SAFETY EVALUATION REPORT AMENDMENT OF NO. 11 TO SOURCE MATERIAL LICENSE NO. SUA-1548 ADDITION OF REYNOLDS RANCH ISL SATELLITE FACILITY

POWER RESOURCES, INC. SMITH RANCH-HIGHLAND URANIUM PROJECT (SR-HUP) CONVERSE COUNTY, WYOMING

January 2007

U.S. Nuclear Regulatory Commission Office of Federal and State Materials and Environmental Management Programs Division of Waste Management and Environmental Protection

Figure1: PRI Environmental, Health, and Safety Reporting Structure (PRI 2004)

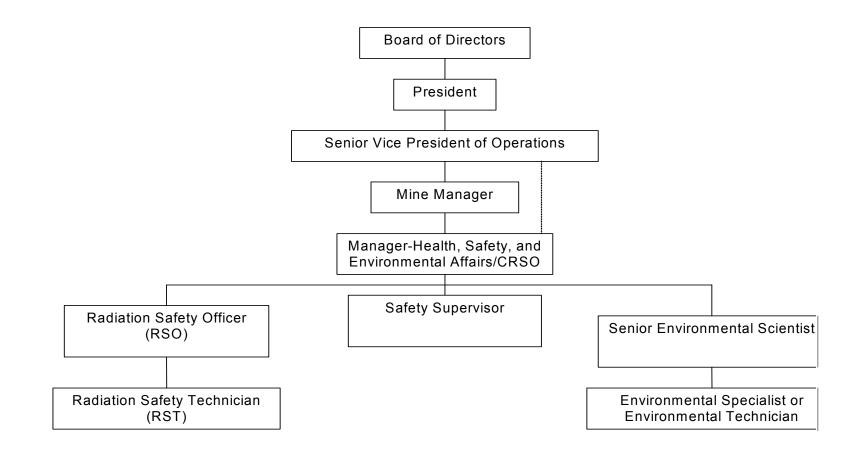
administrative structure flows vertically downward from its Board of Directors and is detailed in the application and other related correspondence [PRI 2004 (Section 9.5) and 2006a]. Figure 1 shows a current partial organization chart for SR-HUP, that includes the proposed Reynolds Ranch ISL Satellite. The management portion of PRI's corporate organization includes its Board of Directors, President, Senior Vice President of Operations, Mine Manager, and Manager-Health, Safety, and Environmental Affairs/Corporate Radiation Safety Officer (CRSO).
